MODERN OUTLINE KITS

BUILD INSTRUCTIONS GWR Armstrong 4-4-0

Loco Chassis Correction P10

17th Oct 2011

Brake gear

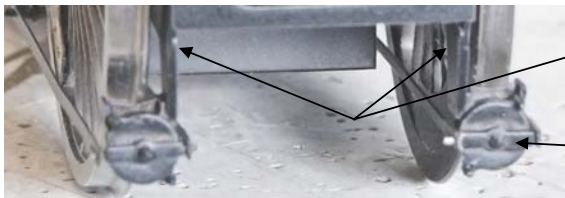
The Brake Hangers may be pinned or screwed (Not supplied) to the Hanger brackets. Brackets are soldered to the chassis

The Shoes are pinned to the Hangers with 0.8mm wire and the Stretchers are made from 1.00mm wire.

The small details B009 for the rodding are found on the brass sheet.

Construction is straight forward with brake rodding assemble both inside and outside of the driving wheels to the actuator at the rear of the chassis.

Brake cylinder brackets are soldered to the inside of the chassis frame. Observe the rebate on the bracket to help position vertically.

Bar at the rear to be horizontal
